COLUSA COUNTY Airport Advisory Committee SPECIAL MEETING AGENDA

August 12, 2021

Request For Airport Advisory Committee

SUBJECT: Golden Roots Nursery (Ranveer Tumber) Greenhouse (Hoop Houses) Project

SE ELEVATION

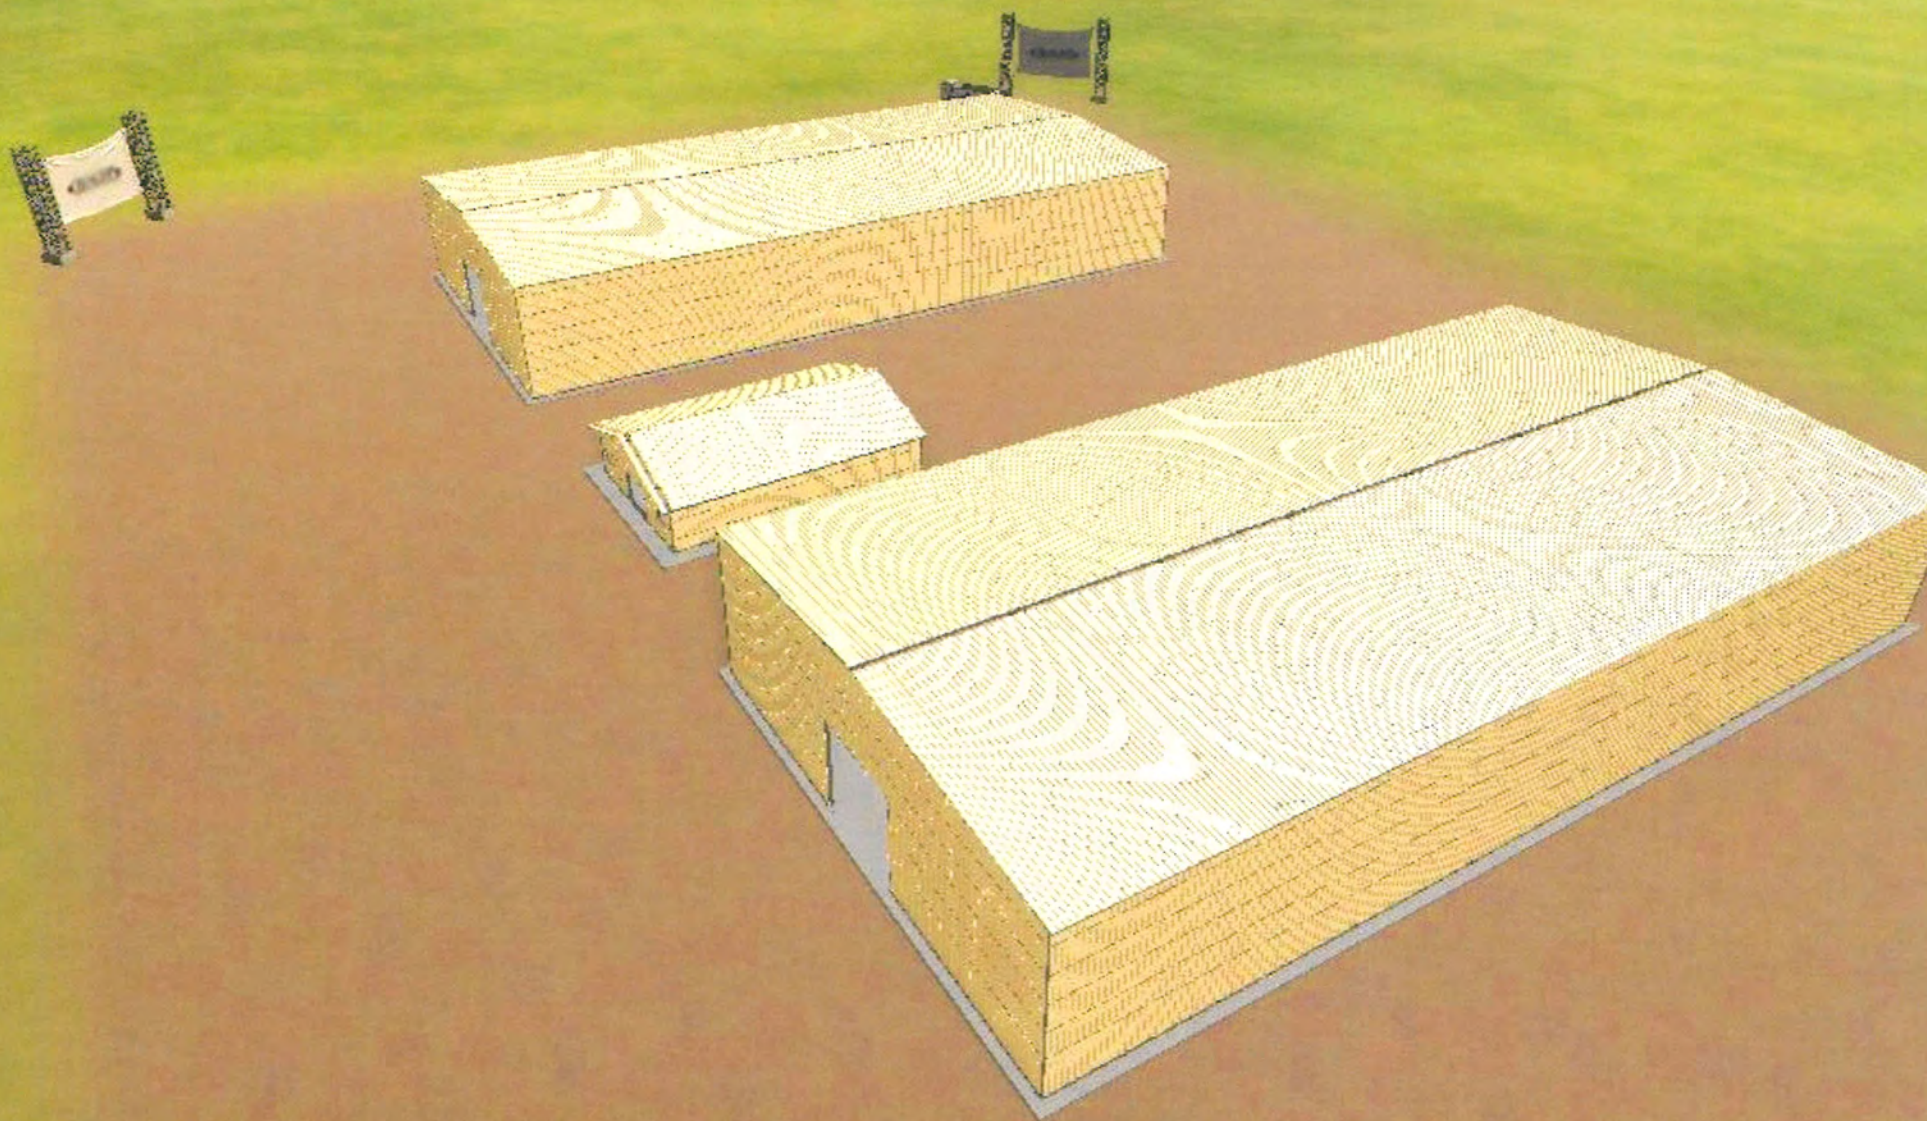
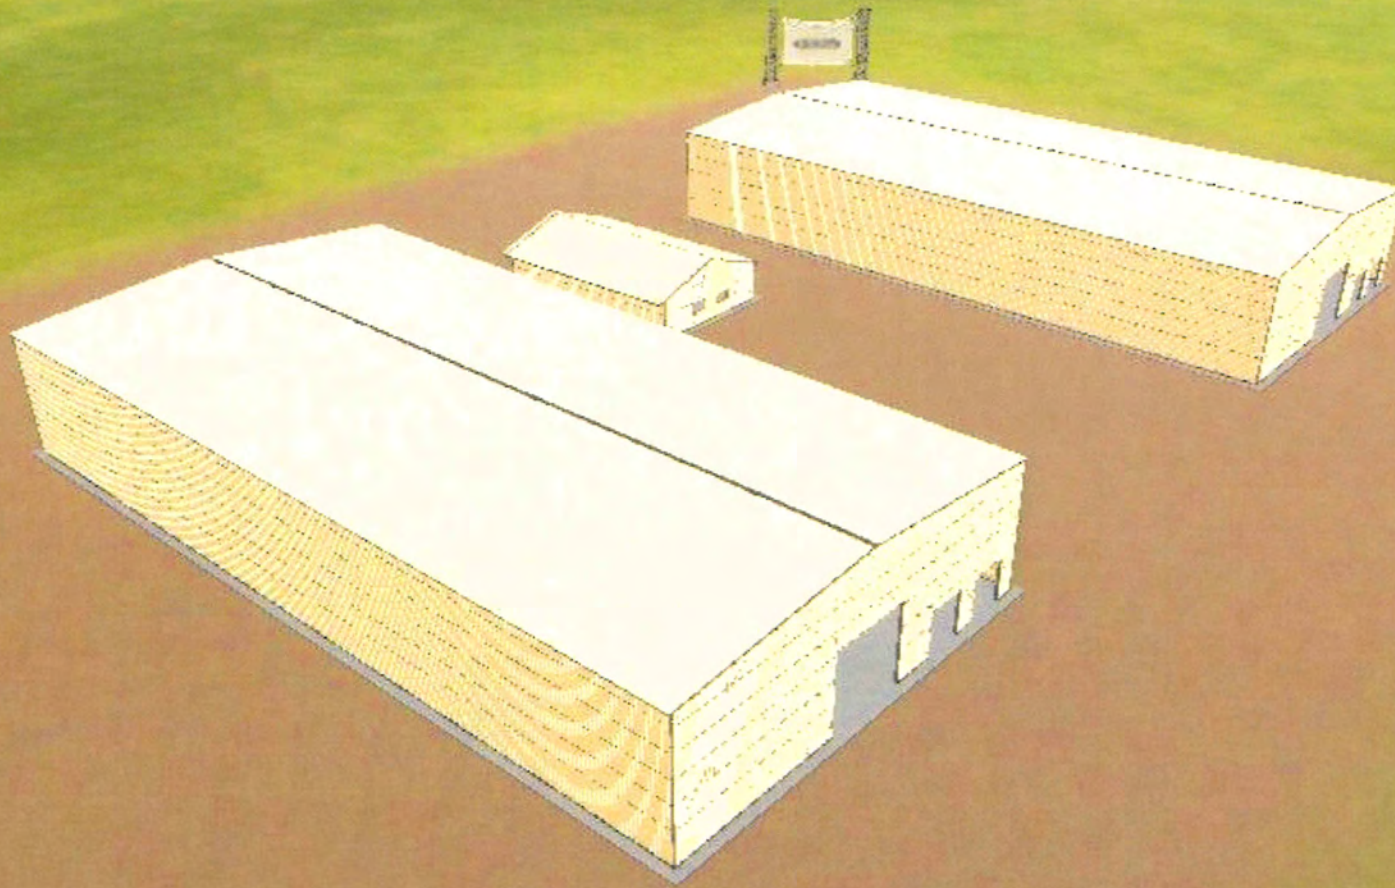
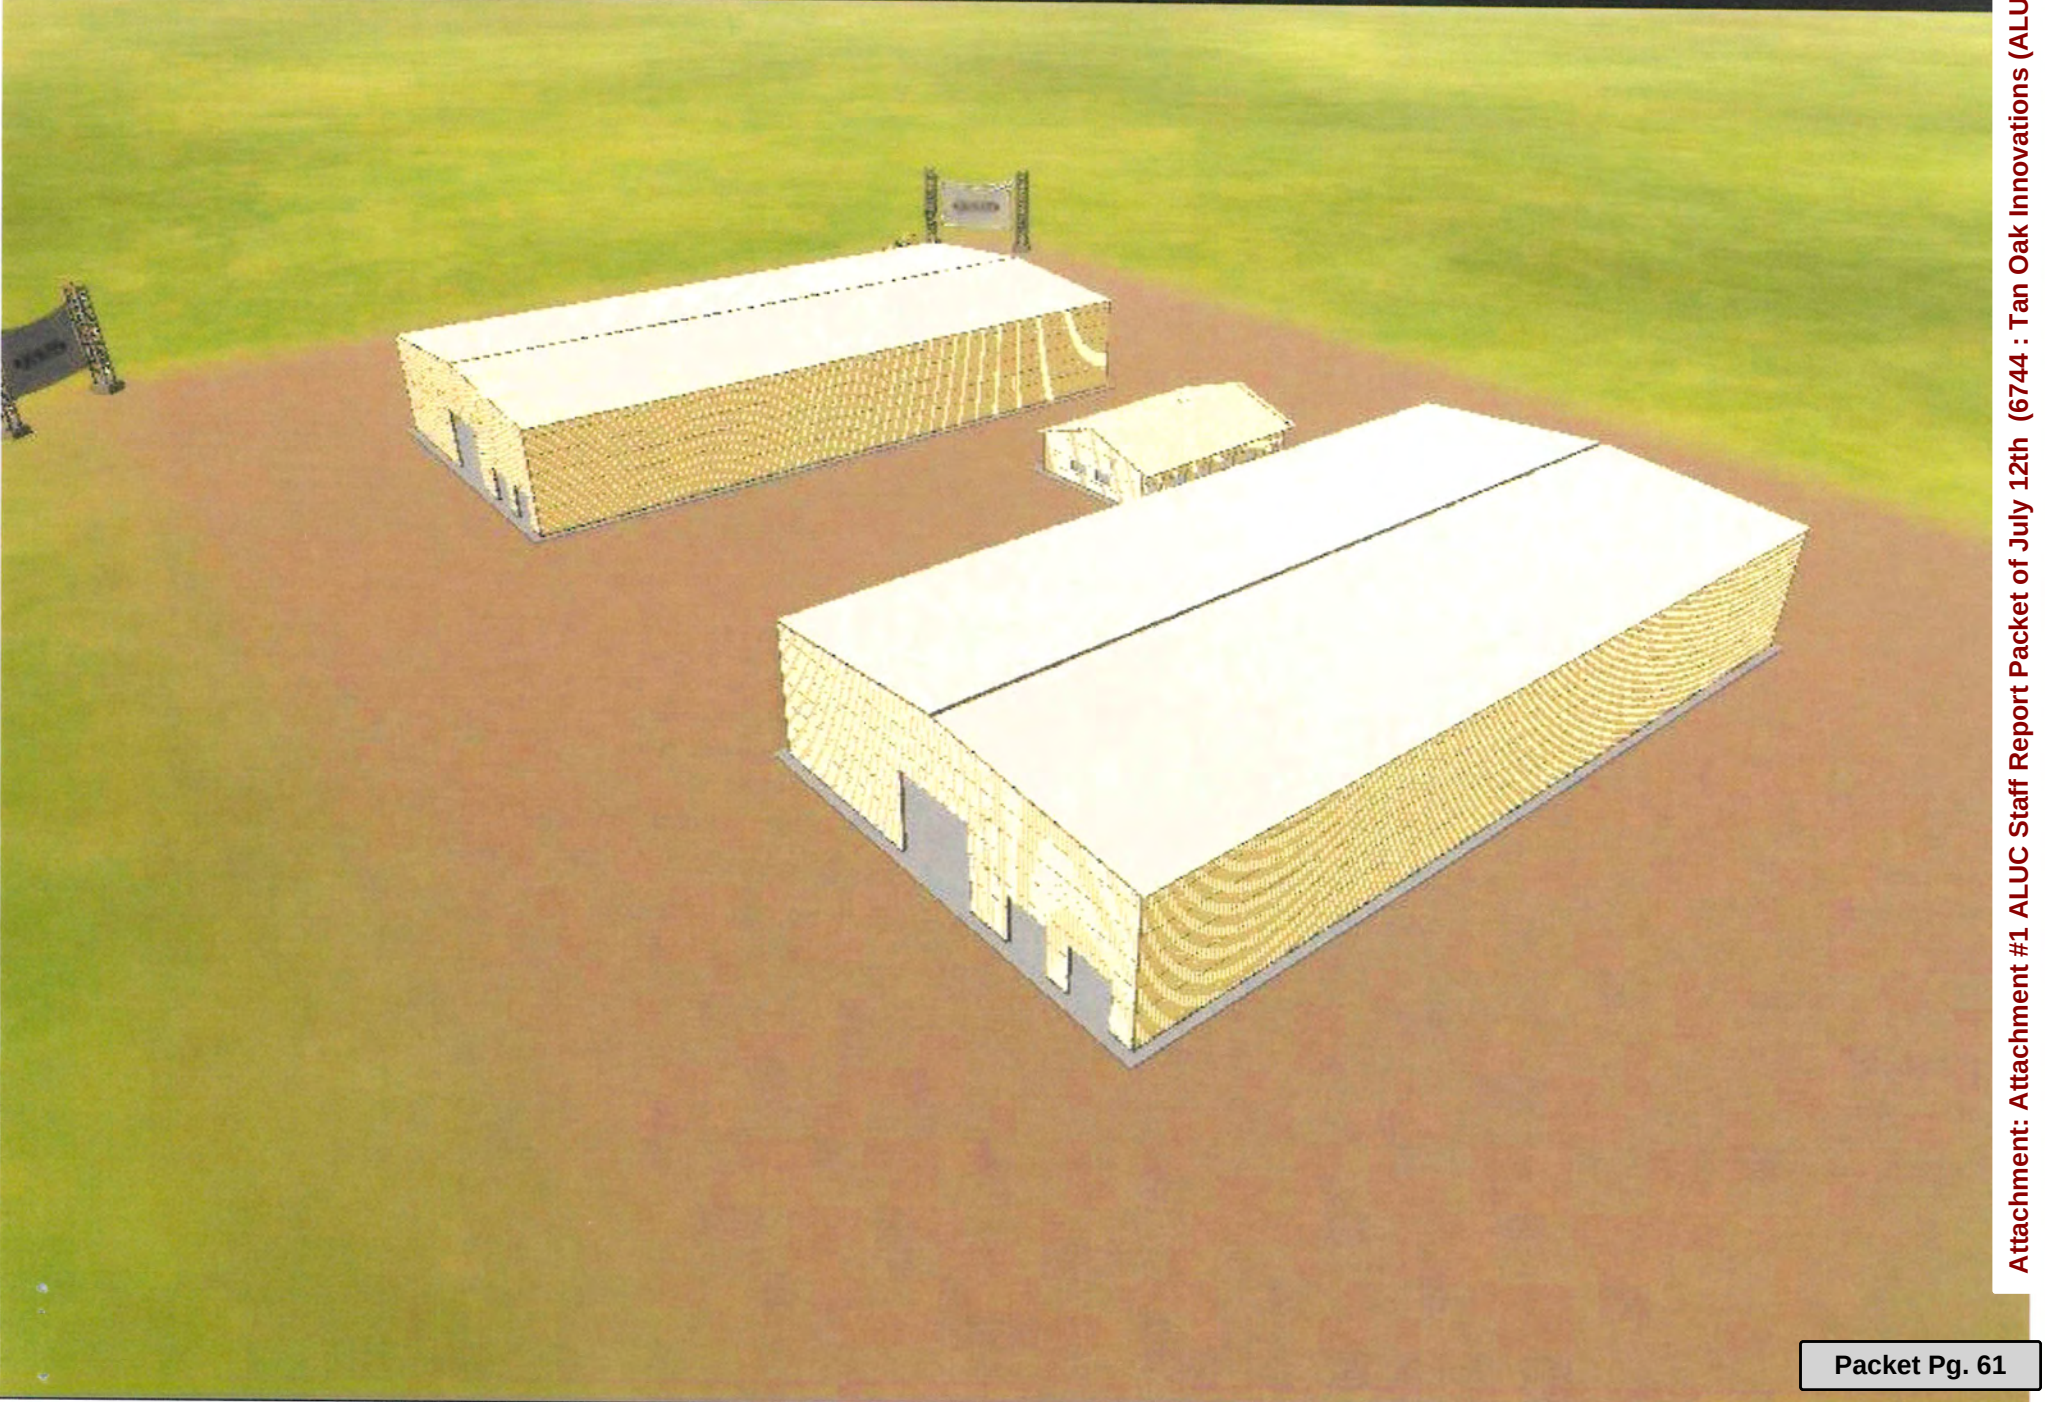
The elevations of the buildings do not show any exterior lighting. In addition, outdoor activity at night would necessitate additional parking lot/storage area lights which have not been shown. Staff believe that this is a minor issue that can be resolved with the requirement that all exterior lighting be shielded and pointed downwards to prevent off-site glare impacts. Any formal consistency finding can include this requirement.

1. The installation of high-intensity and/or unshielded exterior building or other outside lighting could create a negative impact to night-time aircraft flight operations.
2. Any exterior lighting that is installed in conjunction with the proposed development shall be at the minimum intensity level to provide the necessary illumination, shall be shielded to prevent off-site glare impacts, and shall be directed downward to focus the light on the ground.
